T.I. no.: 2019 - 01 Updated: -	Topic: SCA P BF Software 2.01
---	--------------------------------------

Date: 07.01.2019	Priority	Need for action
Affected machines: SCA P BF	High	As soon as possible
From serial number: 1901.../	Medium	On next visit to the machine
As of date: -	X Low	X FYI only

Deactivating reset to standard beverage tab

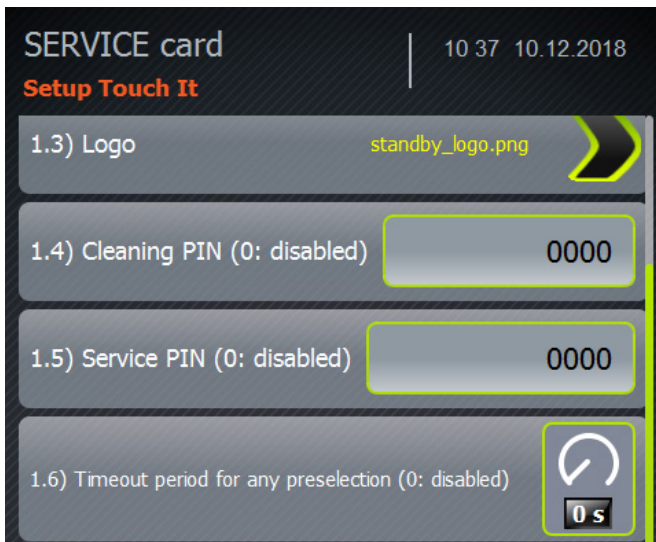
Parameter 1.6 must be set to "0" in the [TouchIT set-up] menu to deactivate automatic changeover to the standard beverage tab.
